June 4, 2018

RE: Collier County Growth Management Plan Amendment Application
Petition PL20170004005/CP-2018-5, proposed Santa Barbara Boulevard/Golden Gate
Parkway Commercial Subdistrict
Review 1 Response

Exhibit "IV.B" (Amendment Language).

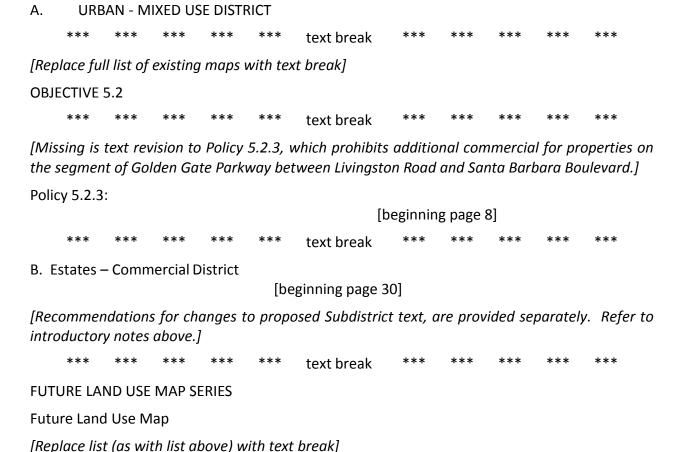
Staff observations, comments and suggested changes appear below. The County Attorney's Office and Comprehensive Planning reviewers have provided recommendations for changes to proposed Subdistrict text, best viewed in their original hand-written mark-ups, which are provided separately and considered part of the recommendations herein. Further revisions may be recommended during subsequent reviews.

Exhibit IV.B has been revised and is included with this submittal.
